## Author Response to Reviews of

# Under-ice acoustic navigation using real-time model-aided range estimation

*Journal of the Acoustical Society of America*

### 2.4 line 89 → 96 (pg. 6)

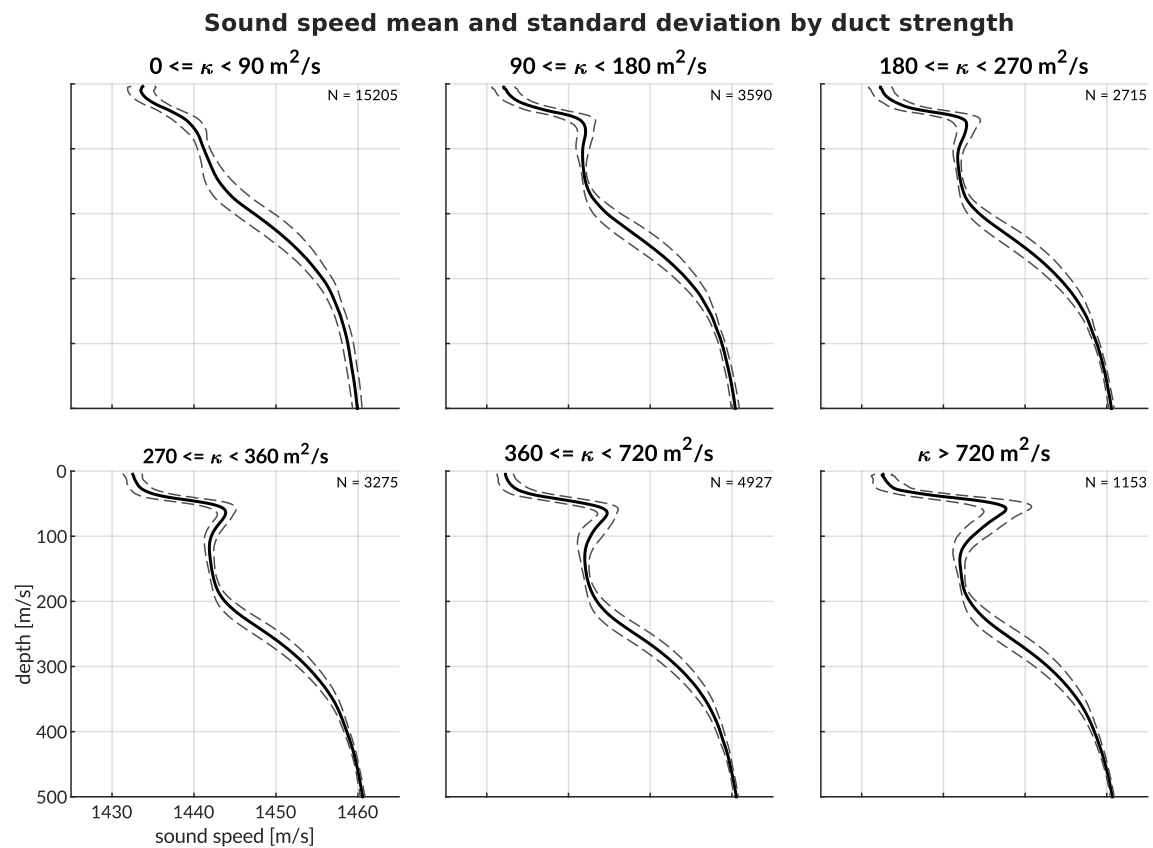
*Is the 'lens' the warm water? Or a combination of layers? What does 'lens' mean acoustically? Normally in ocean acoustics people refer to ducts and layers.*

Please see comment 2.1.
